Planning Commission Preliminary Plan **Meadows of Wintergreen** Springfield Township

EXECUTIVE SUMMARY

Subject: Preliminary Plan Review for Meadows of Wintergreen Phase III

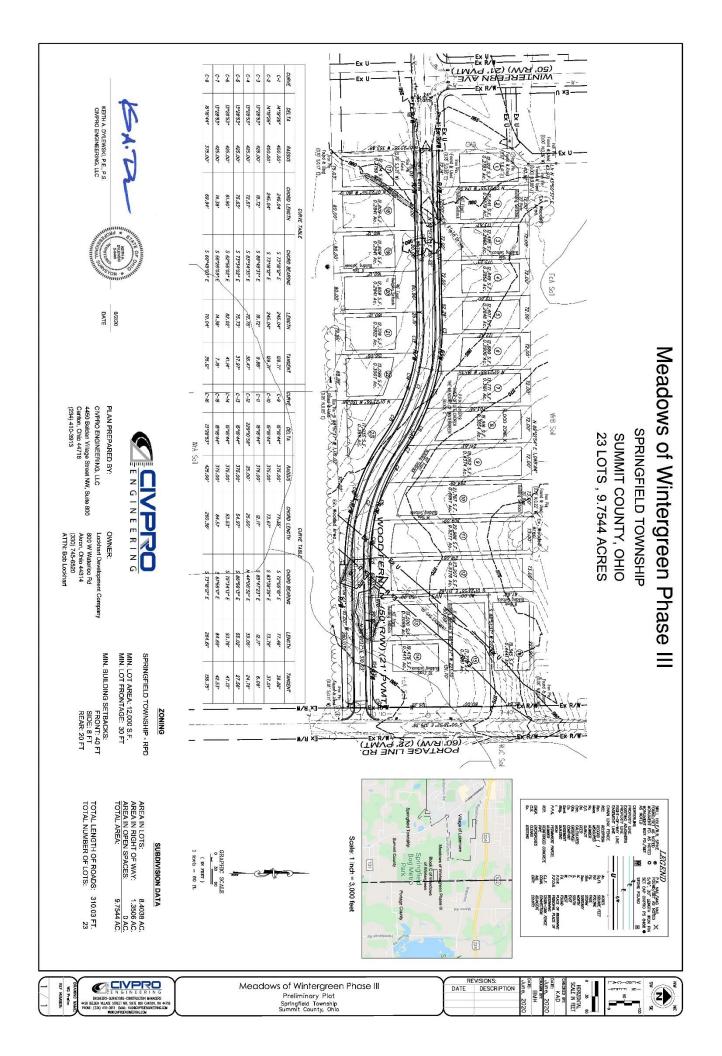
- 1. An updated Stormwater Management Report in compliance with Section 2.3 of the SCE Drainage Manual, Current Edition is required for this subdivision. The improvement plans will not be reviewed until an updated report has been submitted.

- 2. The Traffic Impact Questionnaire must be completed to determine if any additional studies or improvements are warranted.
- 3. The minimum pavement width for Wood Fern Lane is required to be 26'. Also, ODOT Curb and Gutter (2.5' in width) and Storm Sewer structures (Manholes, Catch/Inlet Basins, Headwalls, etc...) shall be implemented on the project.

- 4. The tangent length between Curves C1 and C2 will need to be verified. Subdivision Regulation 1108.05 requires a minimum tangent length of 100' between reverse curves.

- 5. The Sublots are required to be numbered consecutively as each section or phase is submitted. The Phase 2 Plat ended with Sublot 66, therefore, this Phase should begin with Sublot 67.

- 6. In conformance with Subdivision Regulation 1108.05, a 10' wide Utility Easement adjacent to the proposed R/W is required. On the South side of Wood Fern Lane from Portage Line Road to approximately 280' to the West, a Utility Easement is not present. However, the R/W has been widened along this section. Is a variance from Subdivision Regulation 1108.05 required?

7. An additional 10' of R/W or permanent Highway Easement along the West side of Portage Line Road shall be dedicated to Summit County.

Subdivision Regultion 1106.02 Design Considerations "Land set aside for Park and Open Space uses shall meet the following design criteria: ... (e) When a Preliminary Plan includes multiple phases, each separate phase must contain a propostionate amount of required Open space unless the Open Space for all phases is being recorded in the first phase Final Plat." The Open Space for all 3 phases of Meadows of Wintergreen had been recorded with the Final Plats of Phases 1, 2 and 2a.

Subdivision Regulation 1104.04 Preliminary Plan: 1104.04(c)(3)D. Minimum building setback lines. Lot 23 does not show the minimum building setback lines.
